Non material amendment to planning consent 2010/5099/P approved on appeal reference APP/X5210/A/11/2161172 as amended by 2014/2877/P

Summary and Recommendations

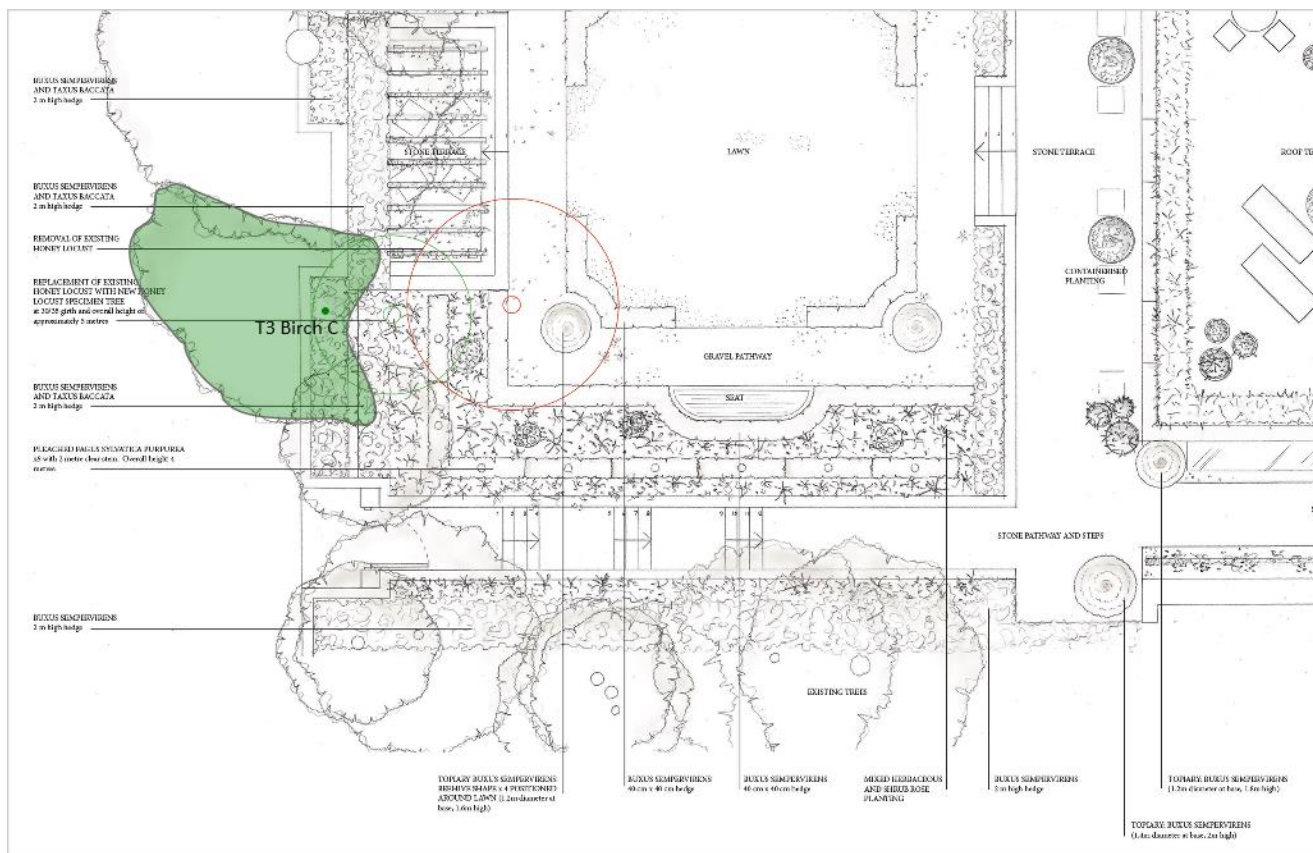
2. Martin Dobson Associates were instructed by Tim Geary of BTP Group on the 29th April to carry out an inspection of a birch tree (T3, centre tree in the photograph below) close to the front boundary of 18 Redington Road, London, NW3 7RG. The birch T3 was designated for retention in planning consent 2010/5099/P approved on appeal reference APP/X5210/A/11/2161172 as amended by 2014/2877/P.

3. The birch was included as T3 in the approved Tree Survey and Arboricultural Method Assessment dated 6 September 2010 and was shown as being retained in the approved landscape drawing, an extract of which is shown below with the birch highlighted in green. The birch was classed as a category C tree of low quality with a calculated root protection area (RPA) of radius 1.4m. It is therefore considered to be of no particular importance and the amenity it affords could be replaced by planting of suitable advanced stock.

10. The tree grows on an angle, leaning towards the wall and the pavement of Redington Road and with the canopy predominantly over the road (as can be seen in the landscape plan above).
